Our Ref: U909  
Your Ref: S01/00200 DA-309-11-2001-I

28 March 2002

**RE: Ashton Coal Mine Project – Camberwell**

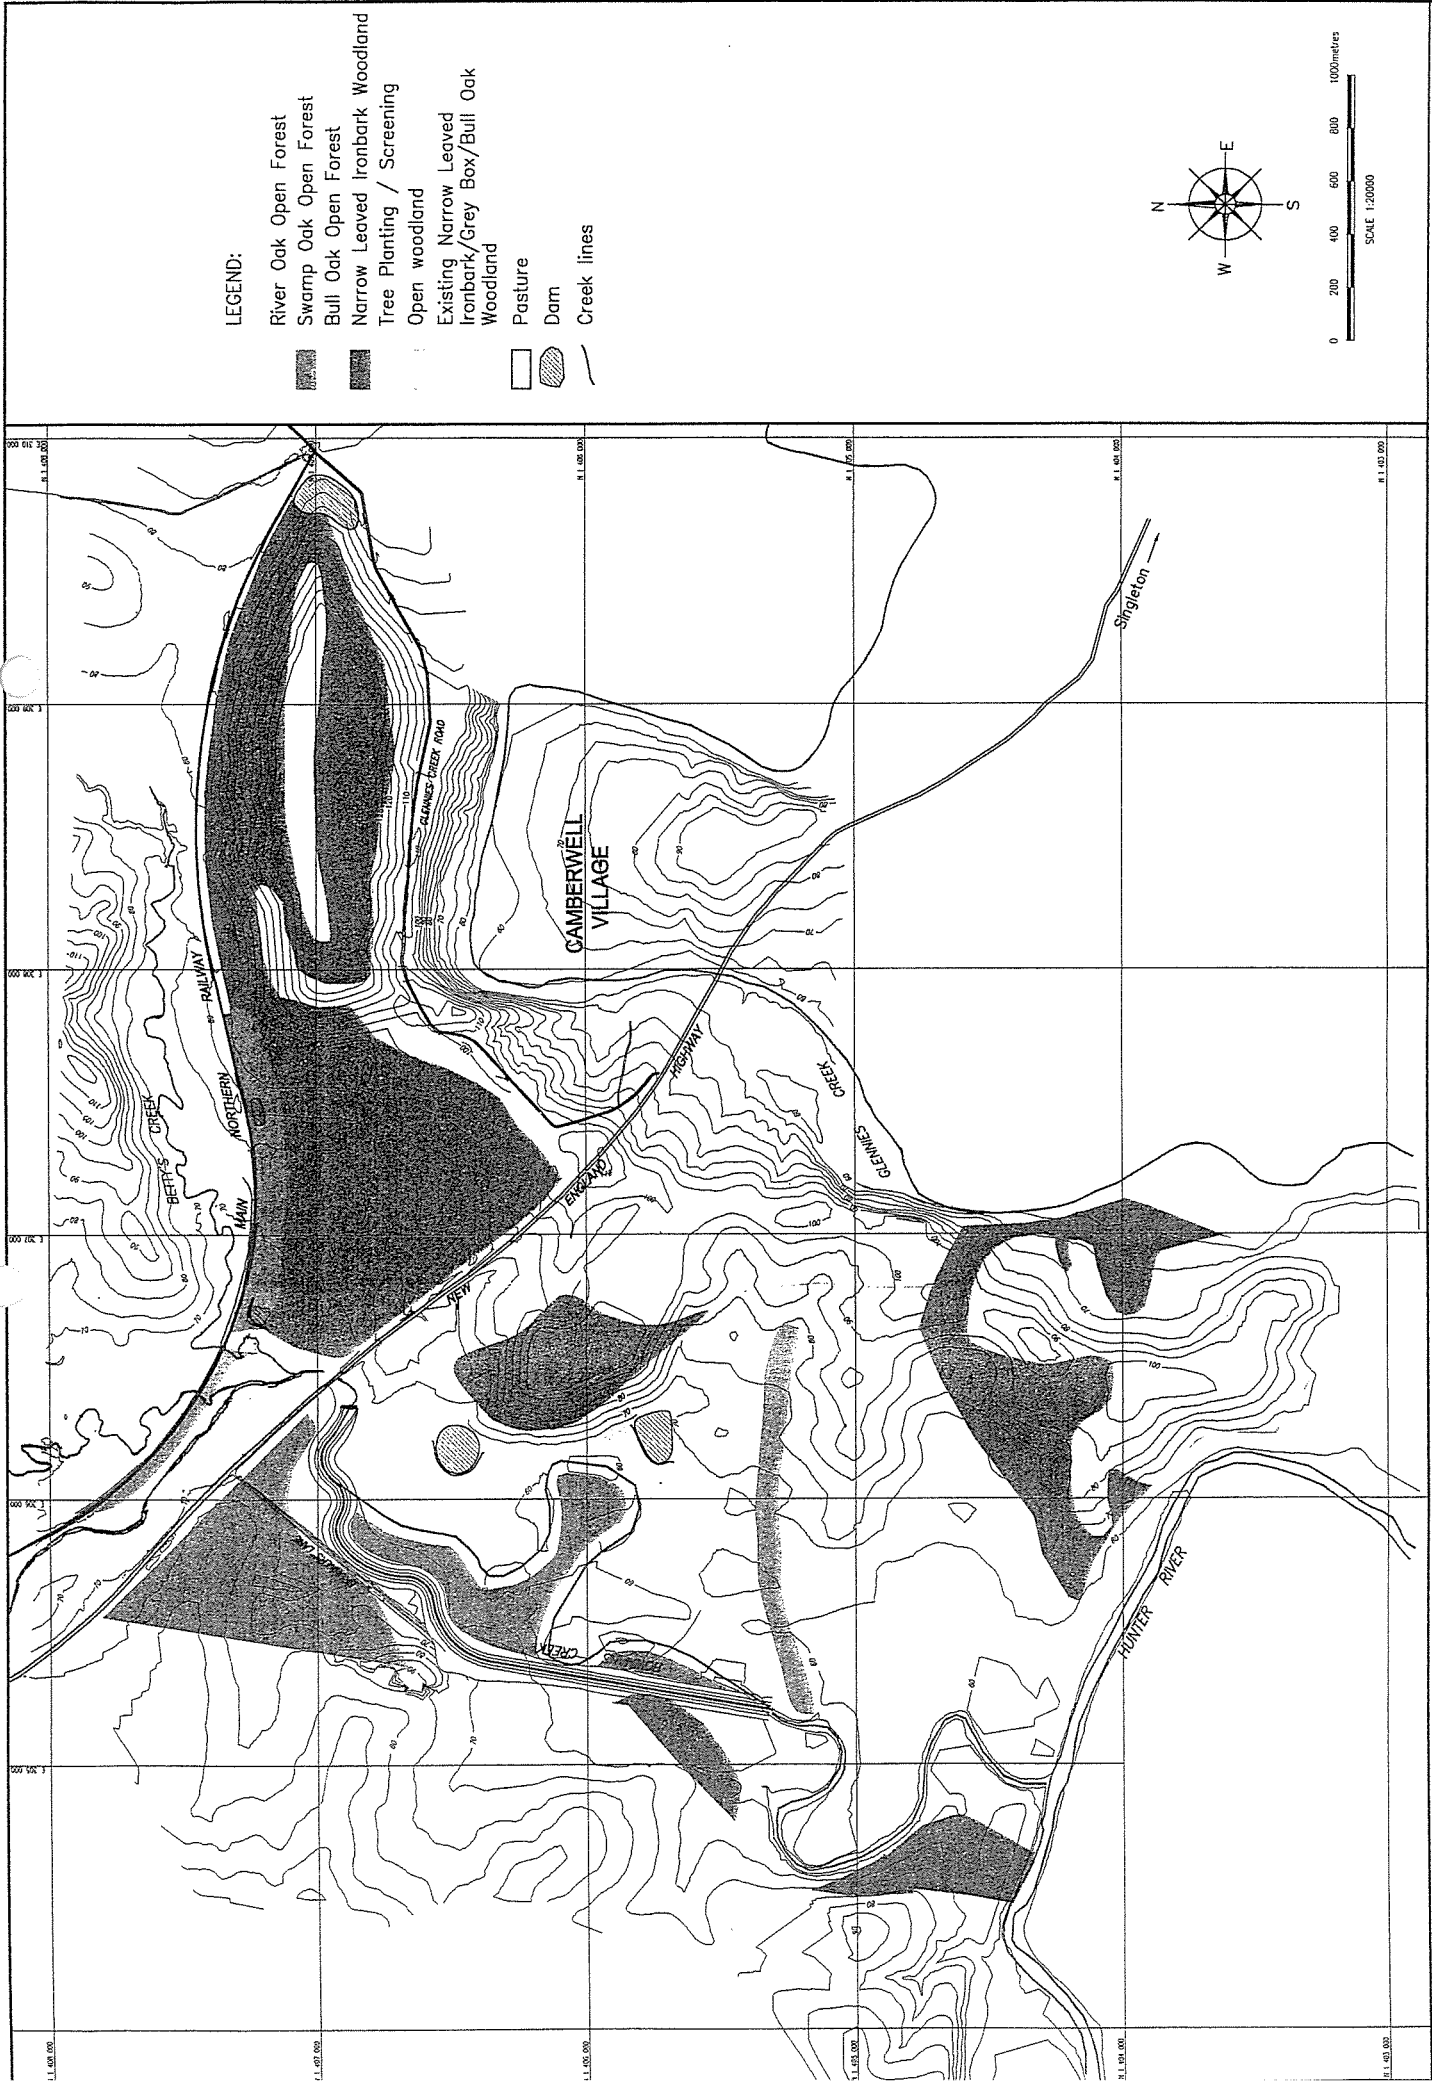
**“Conceptual post-mining vegetative cover plan”**

A Conceptual Landform and Vegetation Patterns has been developed for the Ashton site. This plan aims to satisfy the seemingly competing requirements of sustaining agricultural land and embellishing existing native habitat. Refer Figure A.

A breeding population of the protected Grey-crowned Babbler currently resides in the southern woodland. This is located on Class 3 and 4 agricultural lands. The plan aims to increase the area of the woodland to approximately 200 hectares, which is required for a viable population. The corridors, which are depicted, will link this woodland with the proposed planting in the northern area of the lease area.

A riparian strip of River Oak has been limited to 50m either side of the existing creek bed and creek diversion. This has minimized the impact on Class 1 land, but addresses the need to satisfy the need for aquatic habitat replacement.

Planting of Swamp Oak along the drainage lines and within the Bowmans Creek oxbow area will be undertaken to mitigate the potential impact from soil erosion and potential soil salinity problems.
